To: T10 Technical Committee  
From: Rob Elliott, HP (elliott@hp.com)  
Date: 8 December 2004  
Subject: 04-374r1 SES-2 Define a SAS Expander element

**Revision history**

Revision 1 (8 December 2004) Incorporated comments from November SAS and CAP WGs.

Figure 1 — Examples of diagnostic page contents

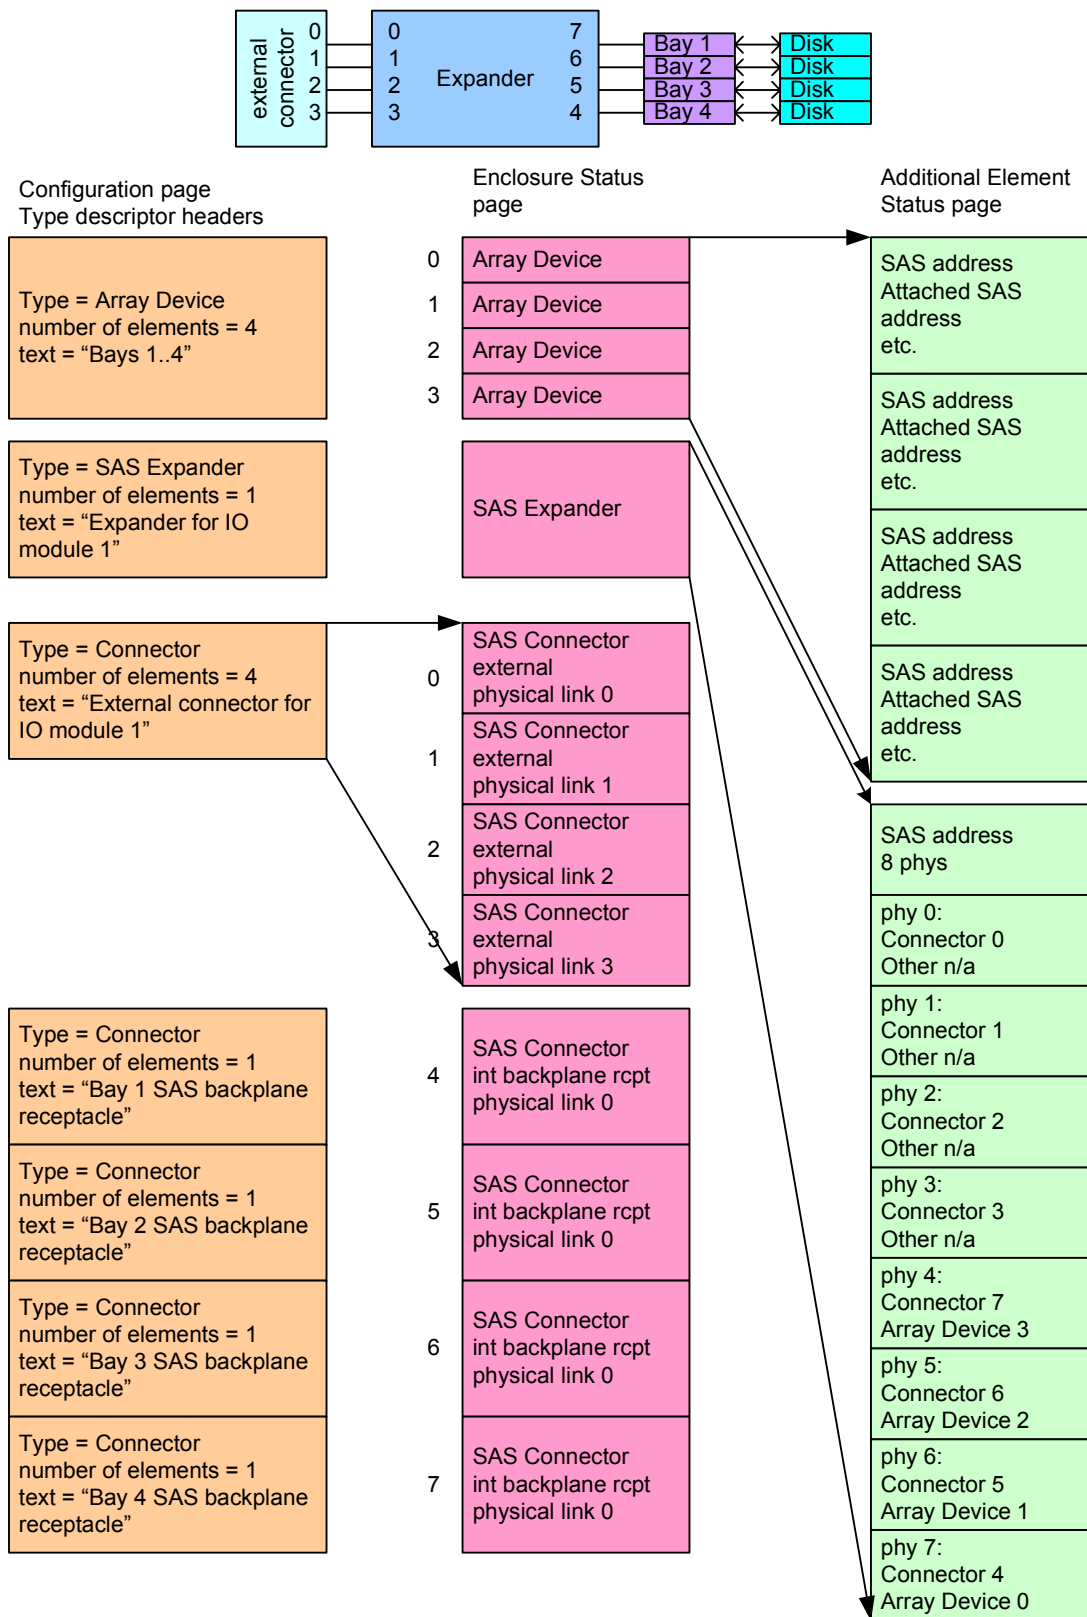
To determine which expanders are located in which enclosures, a new SAS Expander element is proposed. The Device Element Status diagnostic page is renamed the Additional Element Status diagnostic page and expanded to return information about SAS Expander elements in addition to returning that information about Device and Array Device elements.

Additionally, a SAS Connector element is proposed to represent each connector (or specifically, which physically link in each connector) in the enclosure. The Additional Element Status diagnostic page descriptor for each SAS Expander element indicates the SAS Connector to which each phy is attached (if any), and the Device, Array Device, or SAS Expander element (if any) to which each phy is attached.

The following figure is an example of how the Configuration, Enclosure Status (elements), and Additional Element Status pages interact.
